ENVIRONMENTAL COMMISSION MOTION 20250521-002

Subject: Camelback PUD Amendment #3, C814-86-023.03

NAME & NUMBER OF PROJECT: Camelback PUD Amendment #3, C814-86-023.03

REQUEST: Amend a Planned Unit Development

DOCK AREA ENLARGEMENT

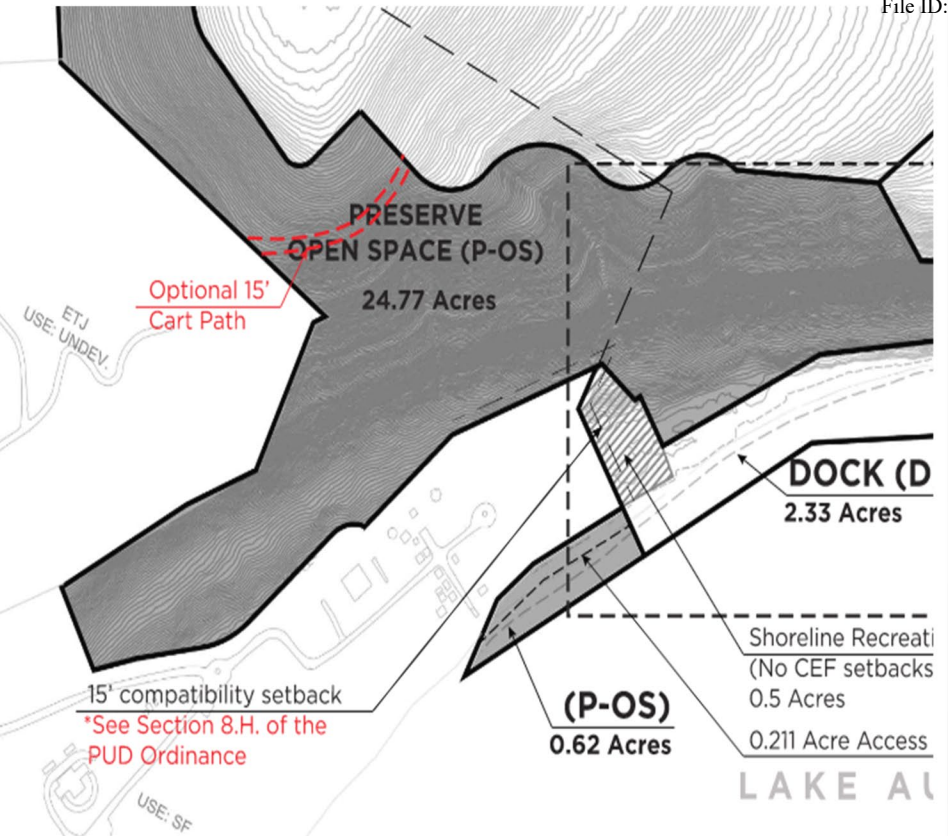
- **Allow for cart path access to Dock District**
- **Modify fill allotments and depth**

Changes to approved PUD linework shown in red.

FUNICULAR TREE IMPACTS

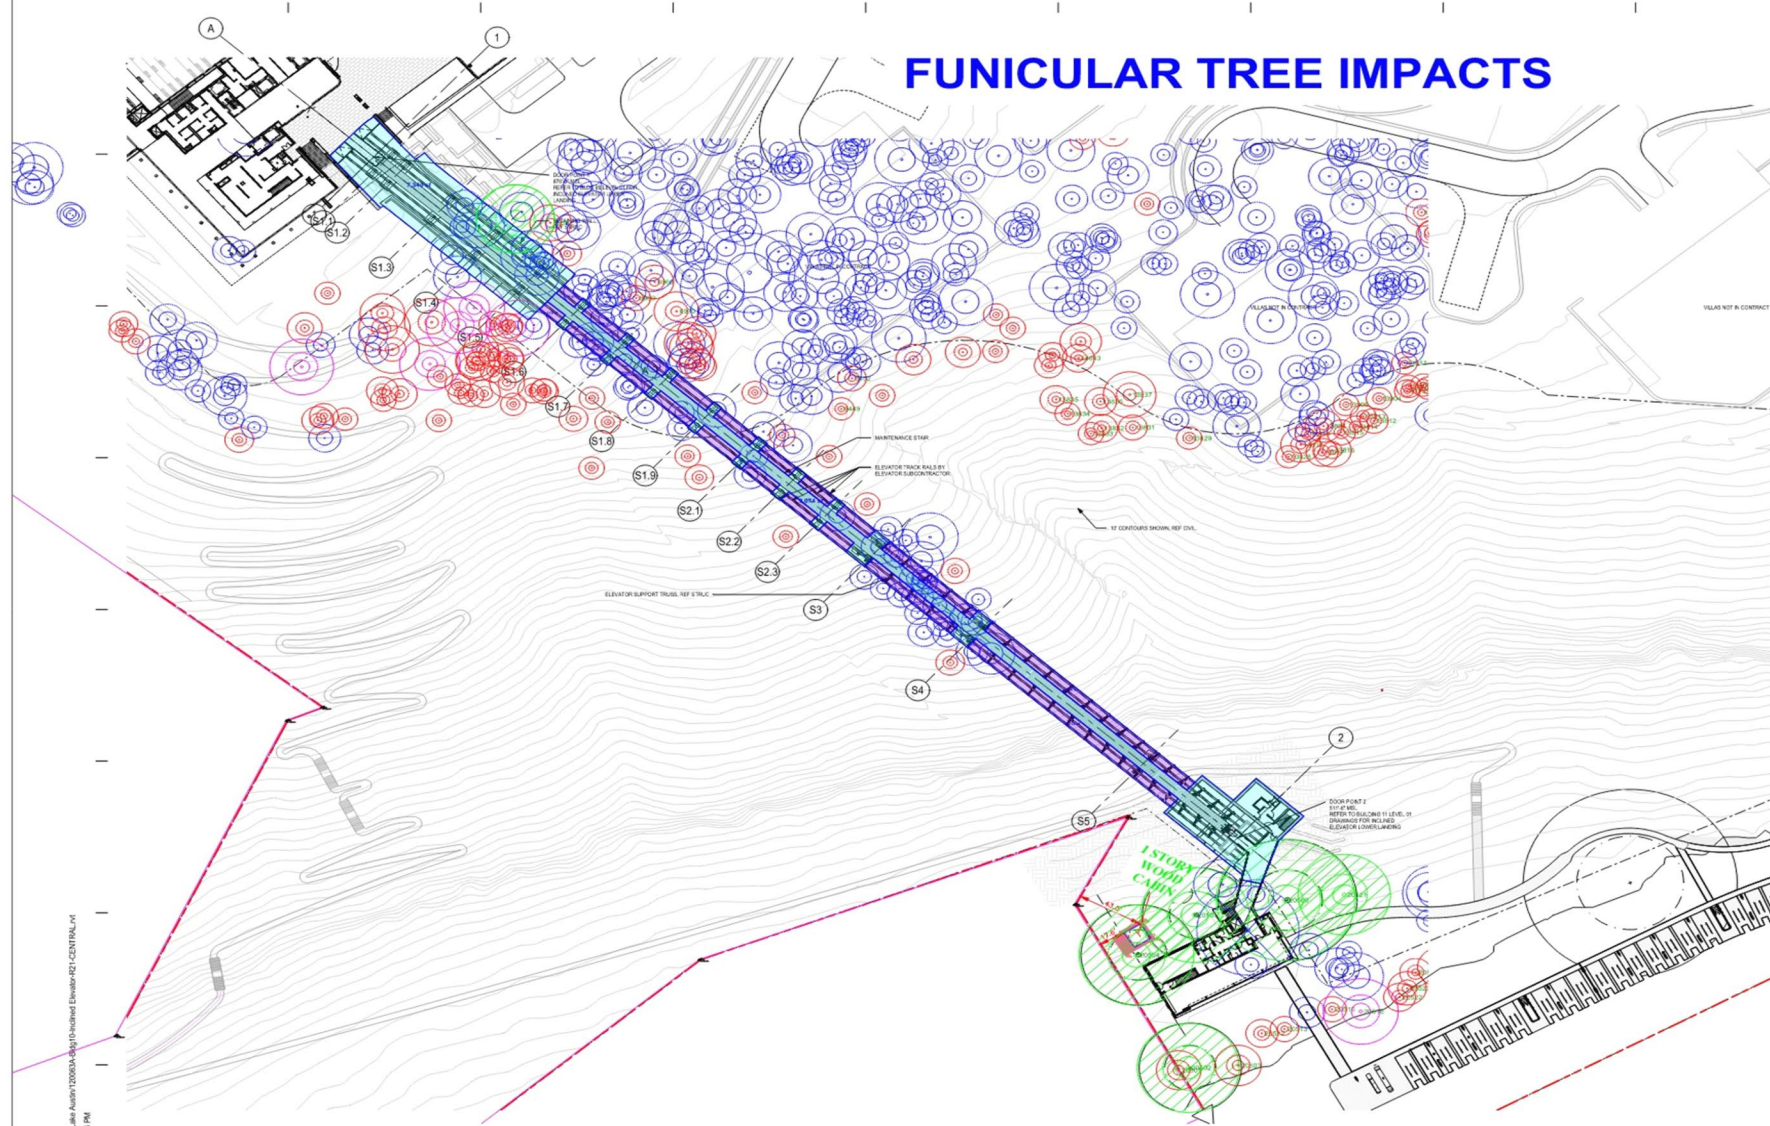
FUNICULAR CONSTRUCTION IMPACTS

Site Disturbance Boundary Entire Area must be cleared of vegetation, including along the cliff face.

CART PATH TREE IMPACTS

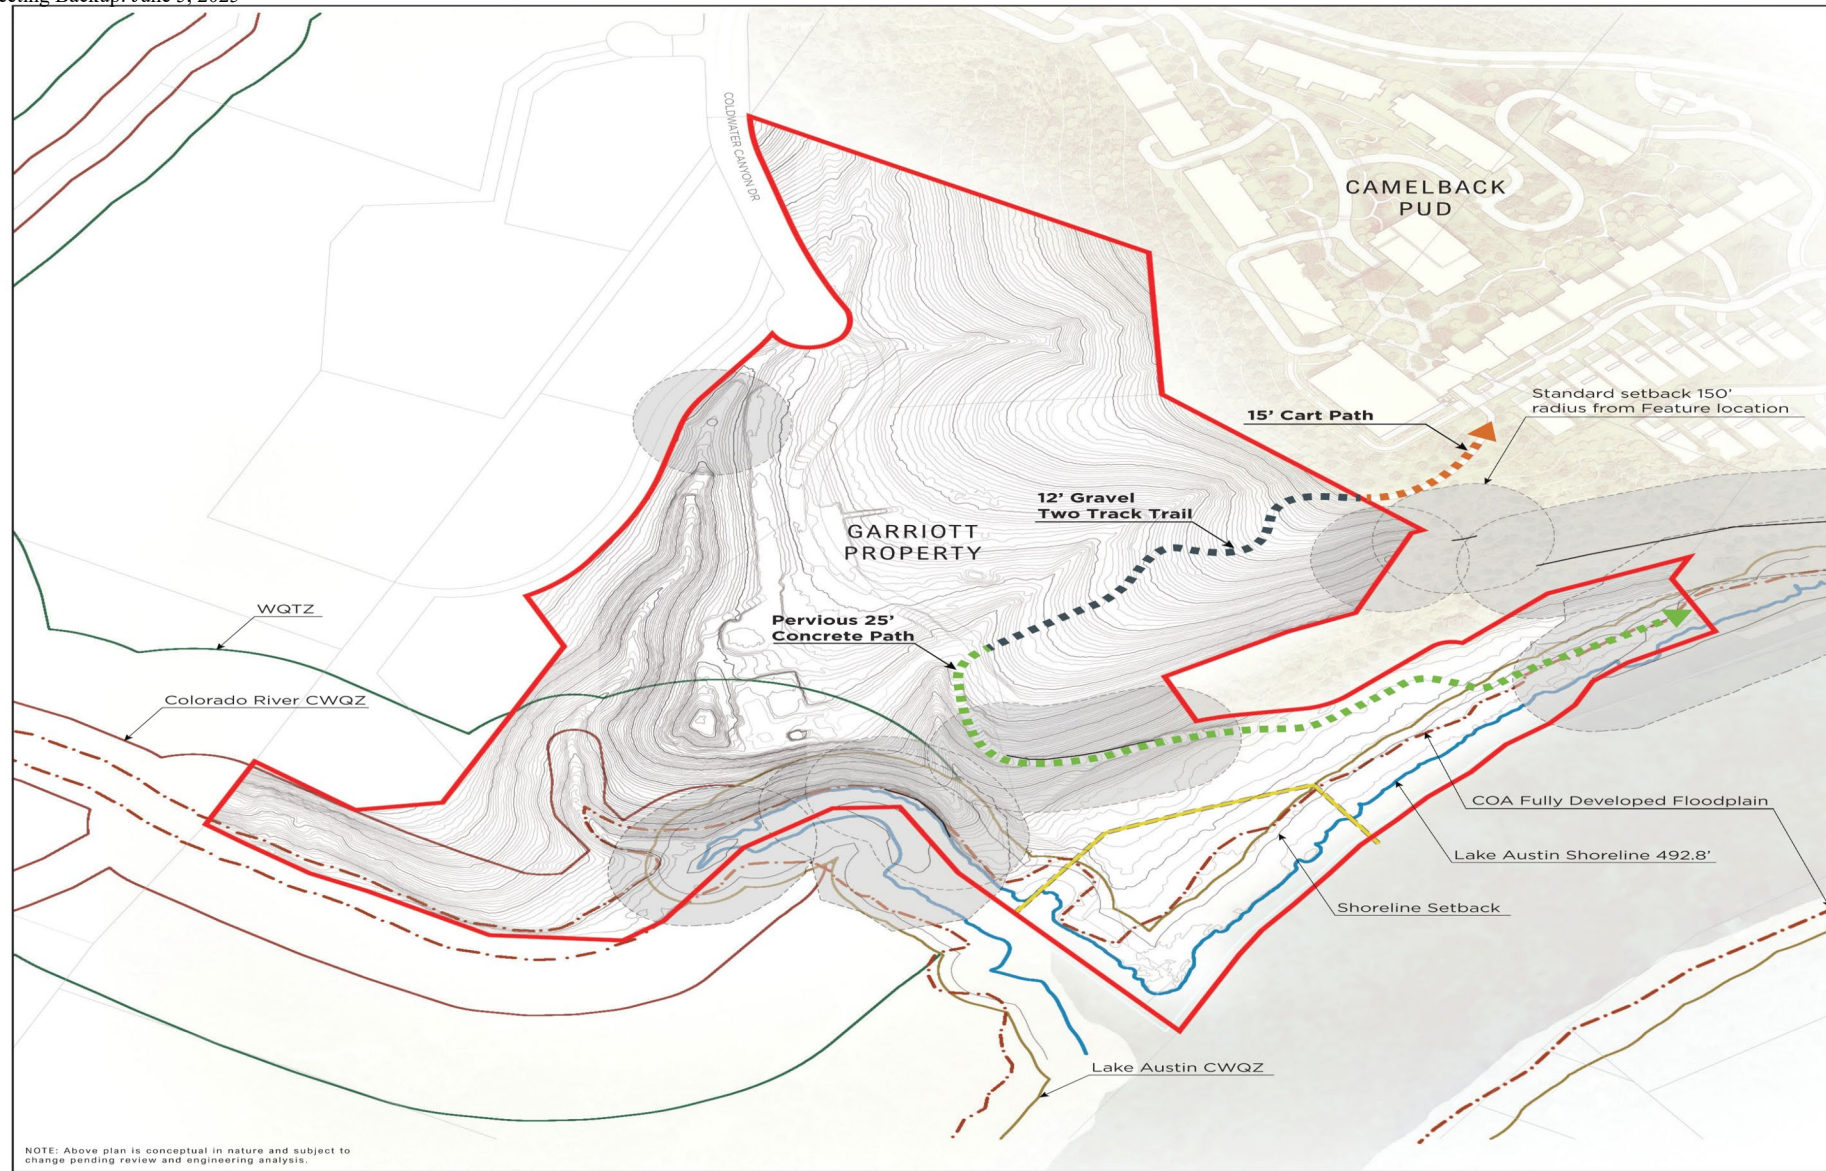
The above plan is conceptual and subject to change based on final design and analysis.

- **PUD amendment allows for an alternative access cart path to the dock district in exchange for the mechanized access (funicular). PUD notes will be added to prohibit additional access once the cart path shown in the revised PUD has been constructed.**
- **Cart path will not impact critical environmental features (CEFs) and will otherwise comply with environmental regulations**
- **No additional cut will be allowed other than what is already provided by the approved PUD**
